STATE OF MAINE
DEPARTMENT OF TRANSPORTATION
16 STATE HOUSE STATION
AUGUSTA, MAINE 04333-0016

November 18, 2022
Subject: Bridge Rehabilitation
State WIN: 021751.01
Location: **Boothbay Harbor & Southport
Amendment No. 5**

Filename: ... \MSTA\034_Deck_Grid_01.dgn

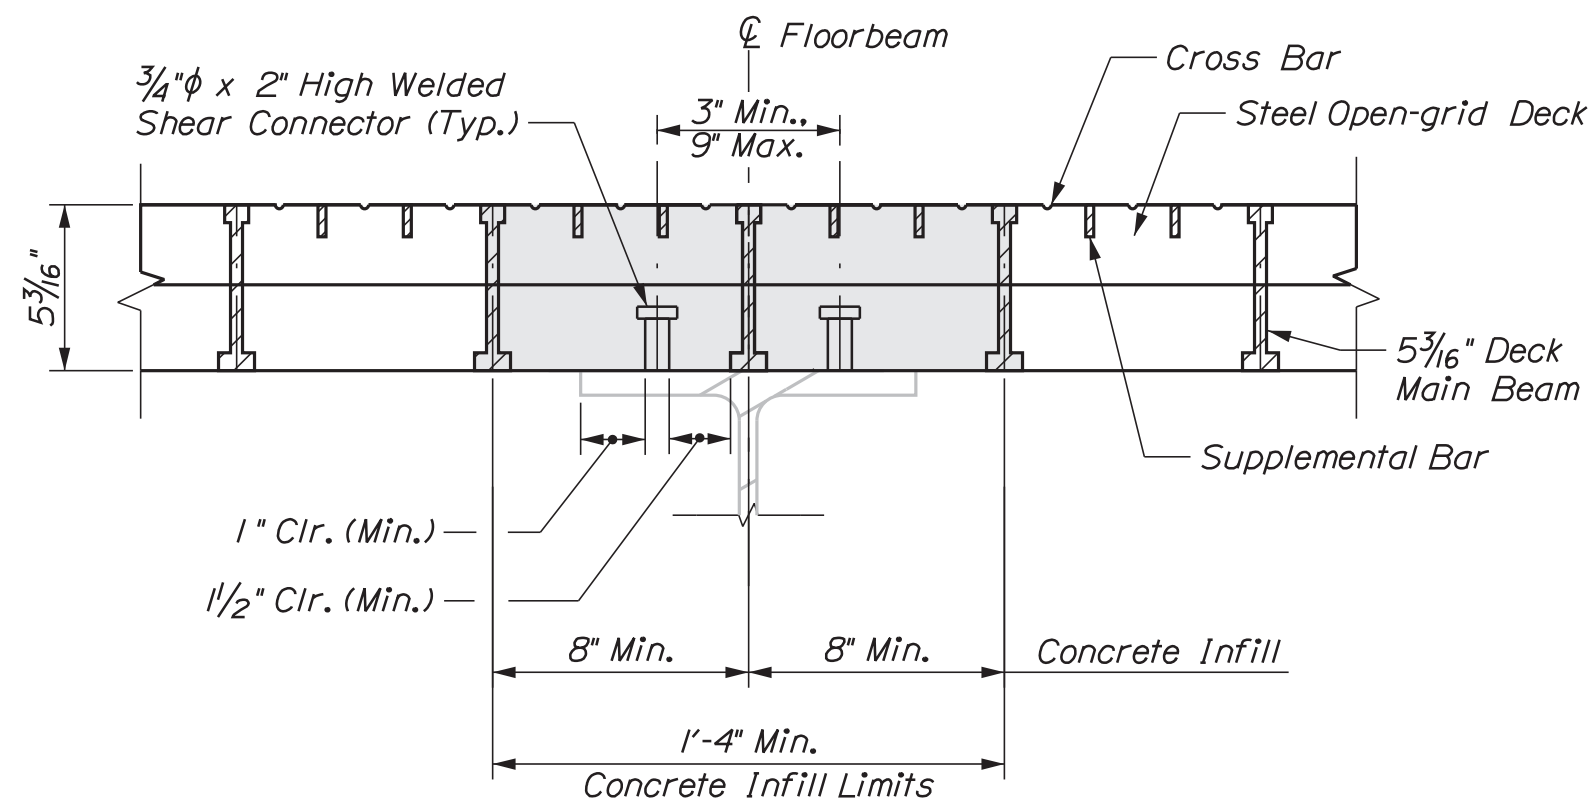
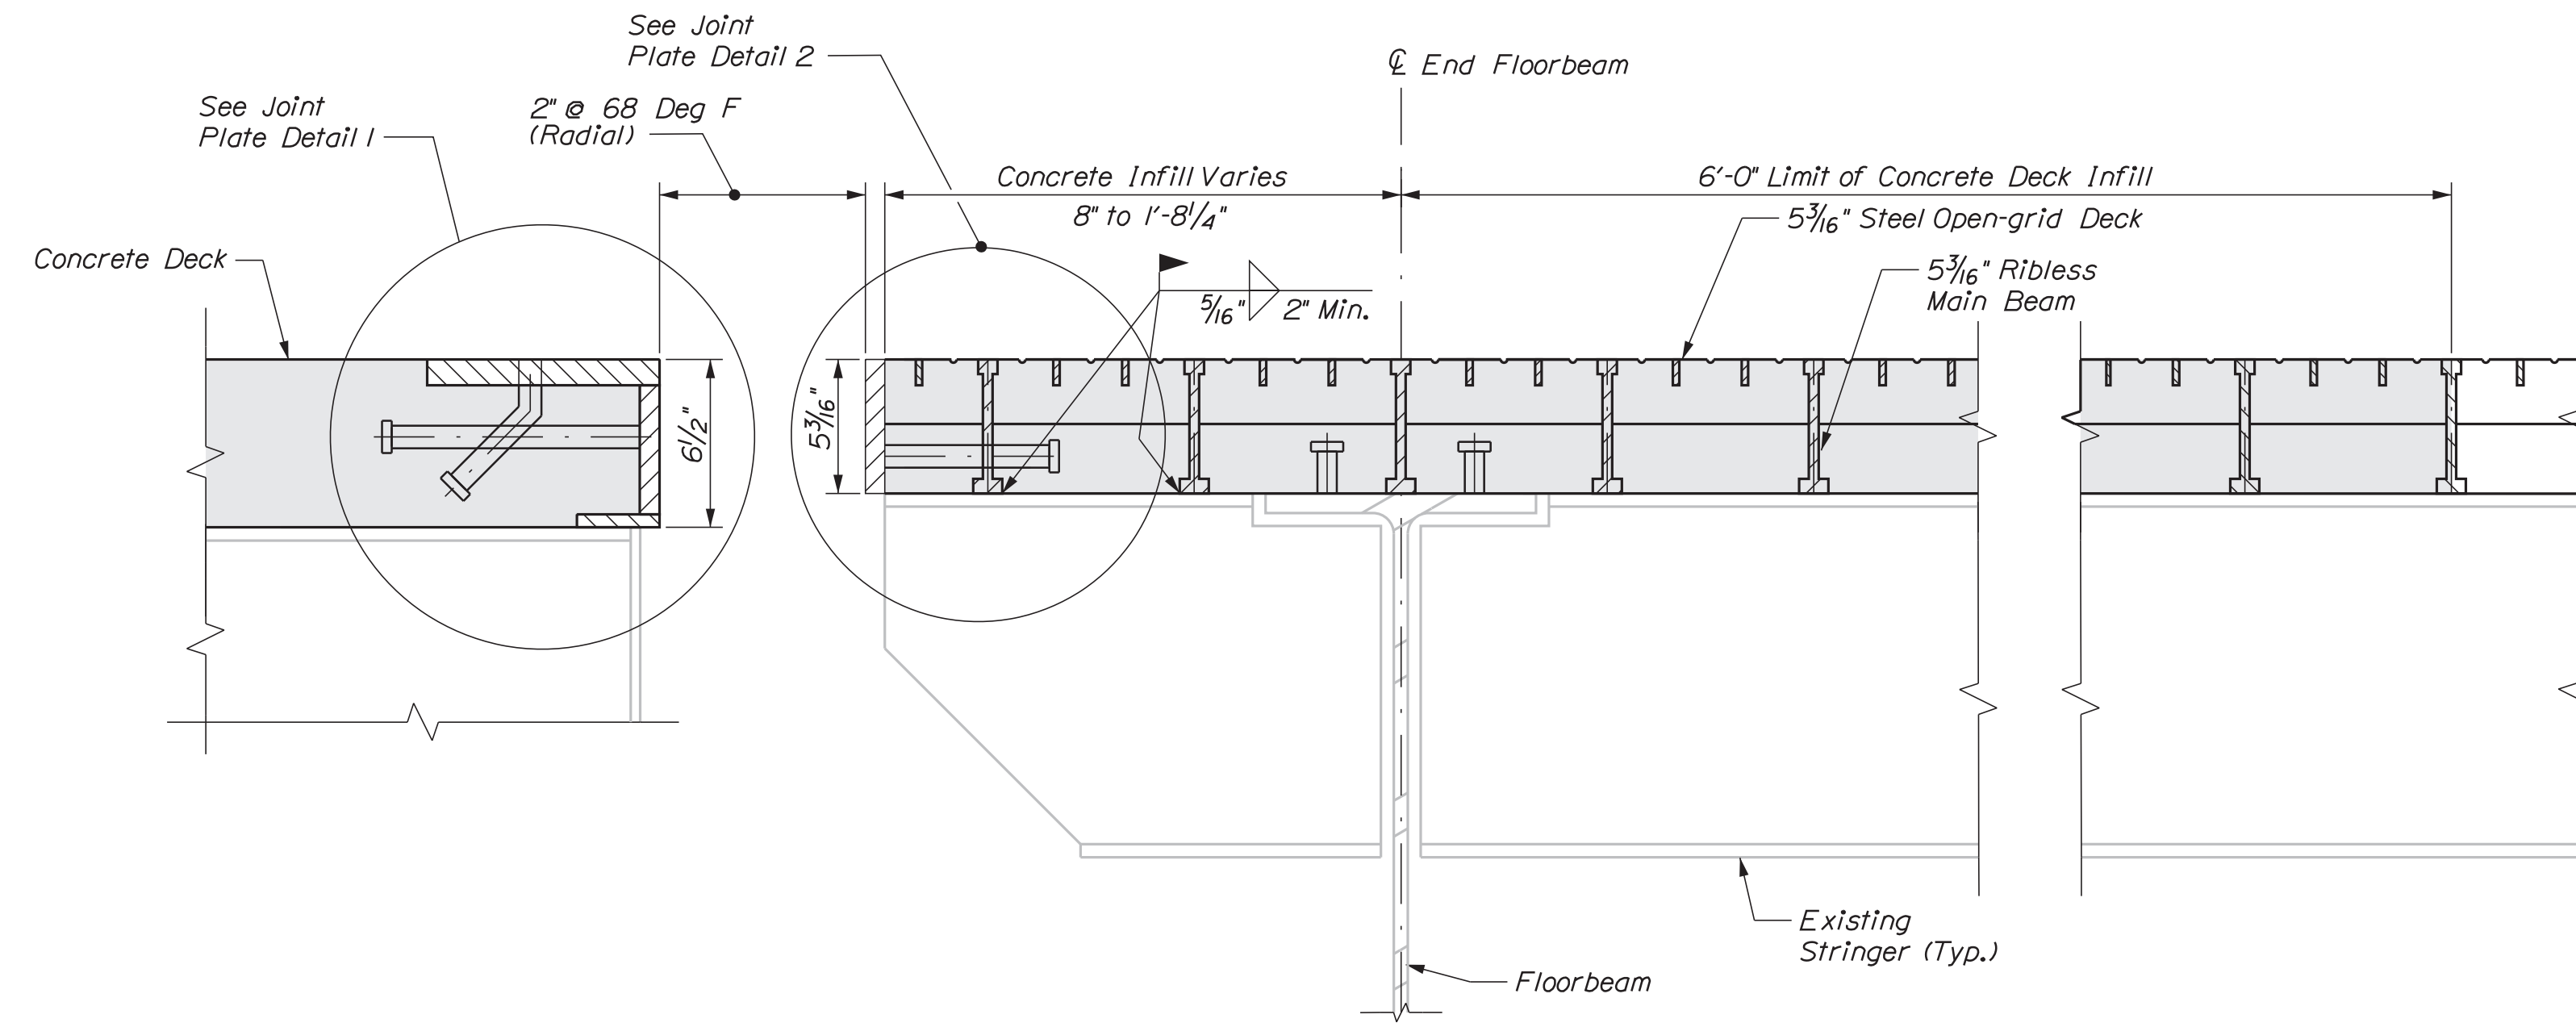
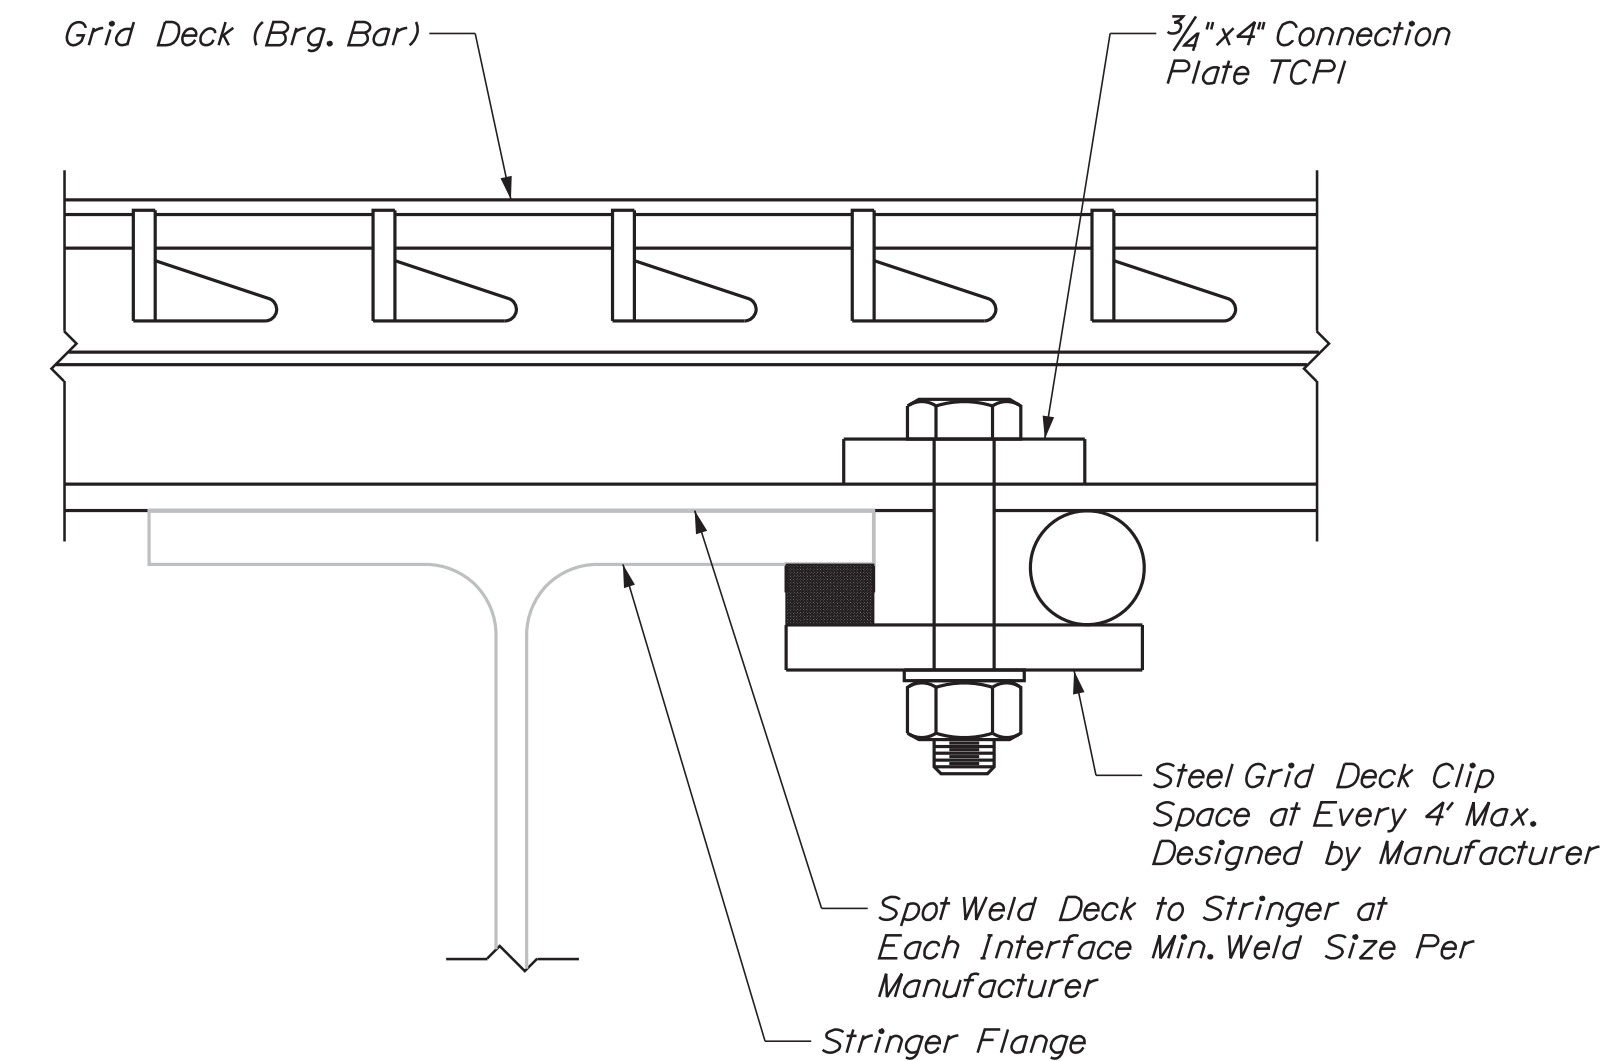
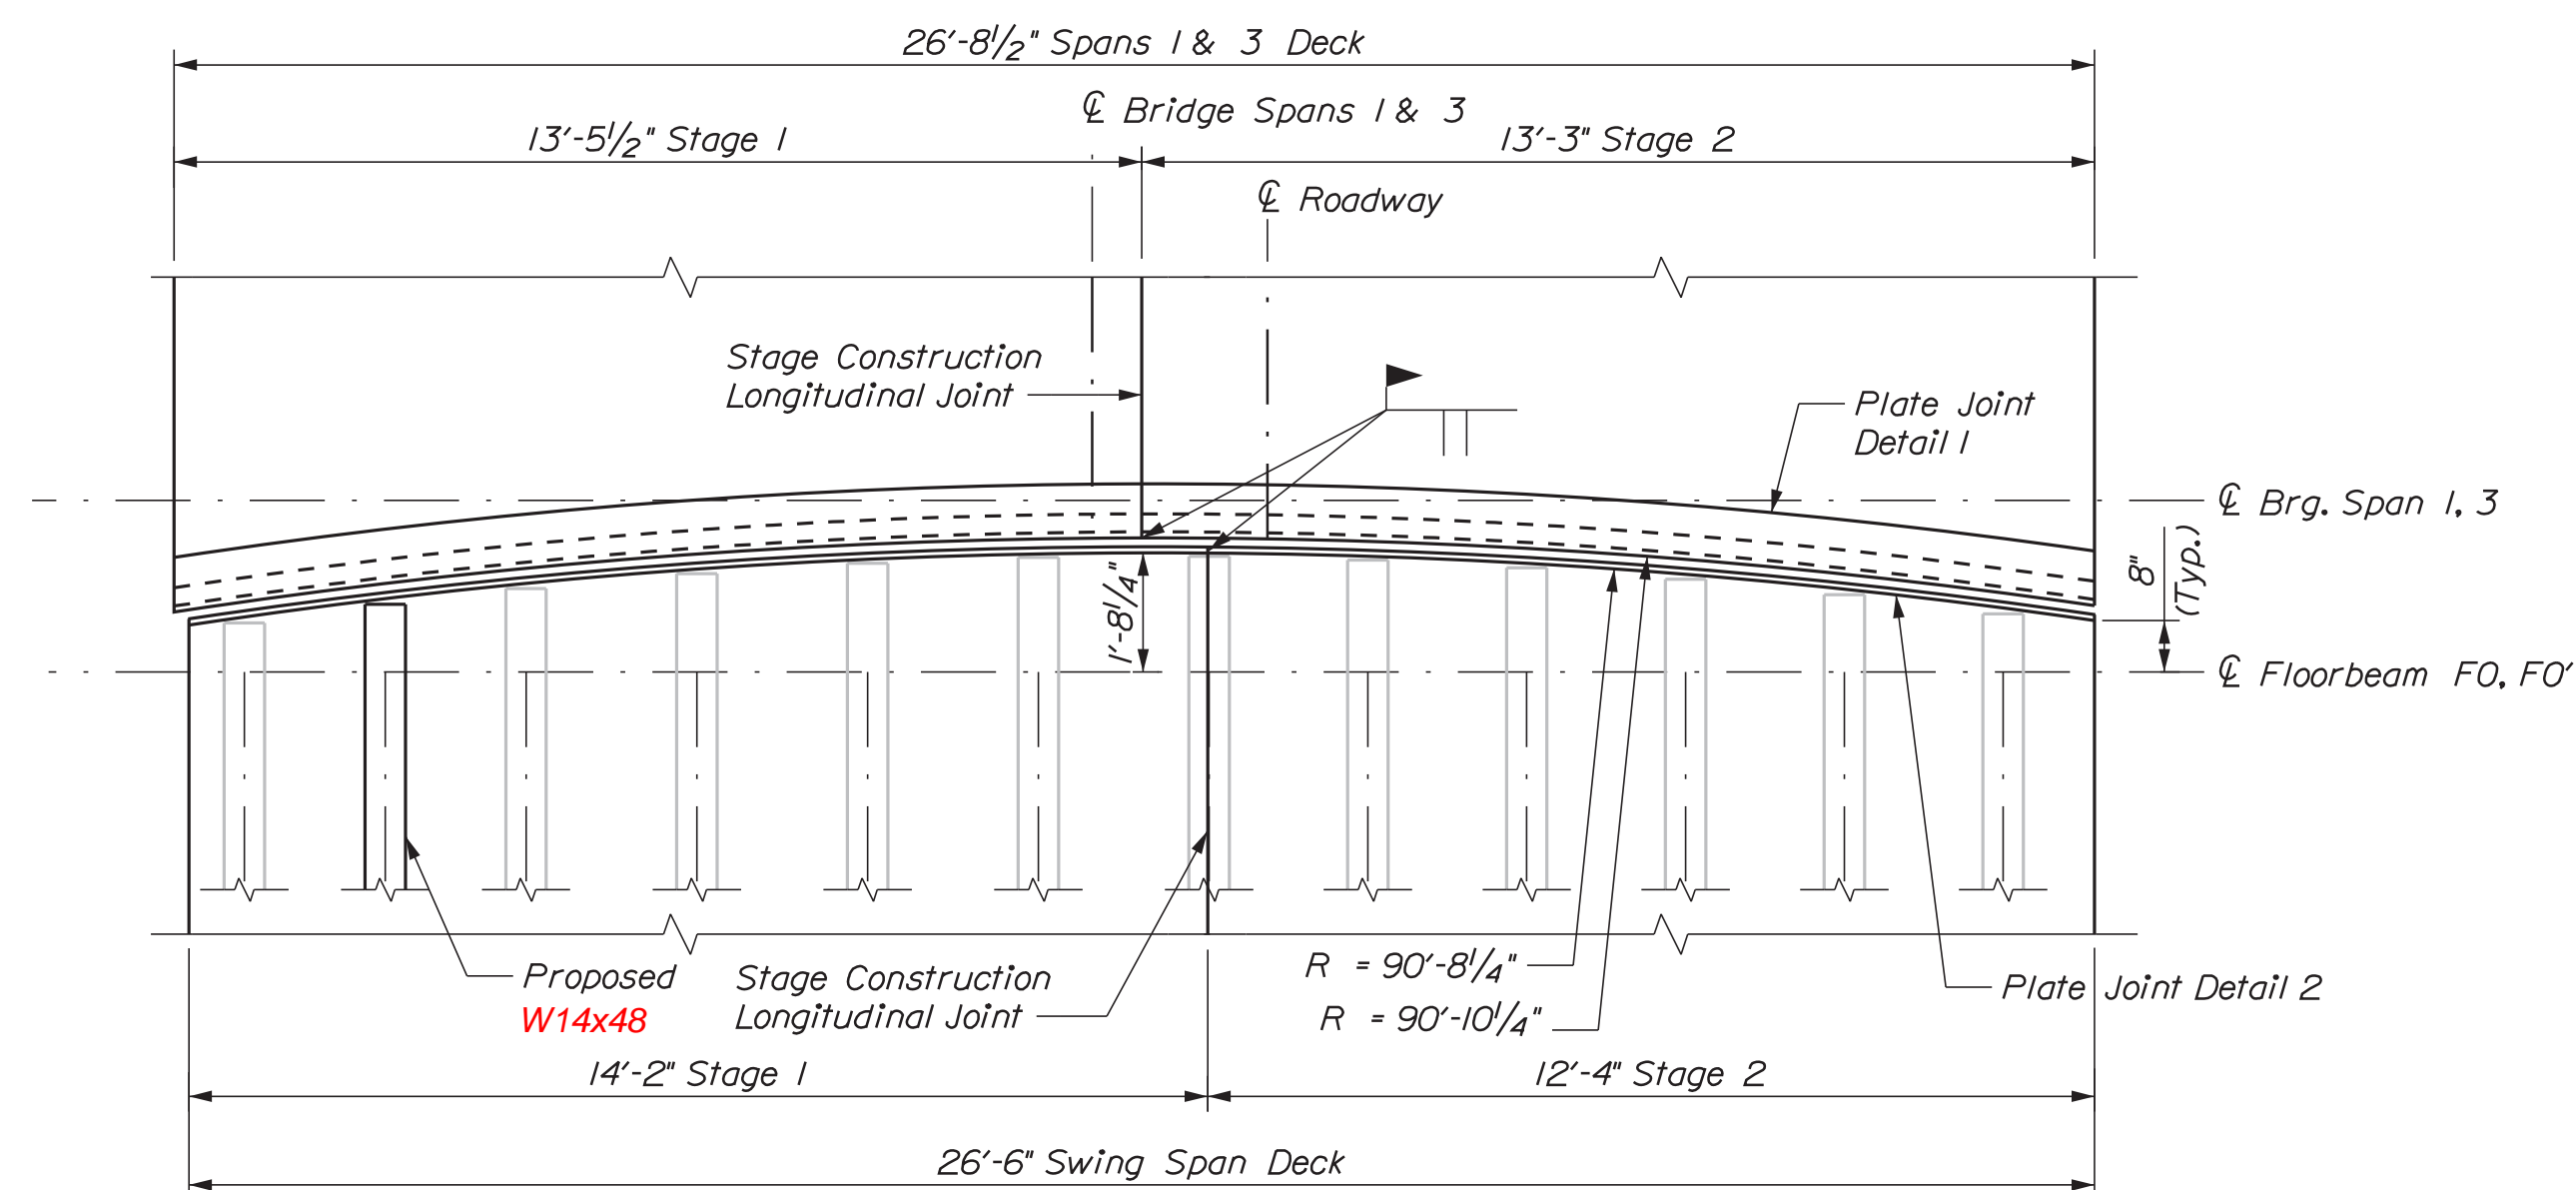
Question: Please refer to drawings 31 & 34, there is a conflict regarding the proposed stringer size; 31 shows w14x48 and 34 shows 14x42, please clarify.

Response: The correct proposed stringer size is W14x48 as shown on plan sheet 31 of 48. Plan sheet 34 of 48 has been revised.
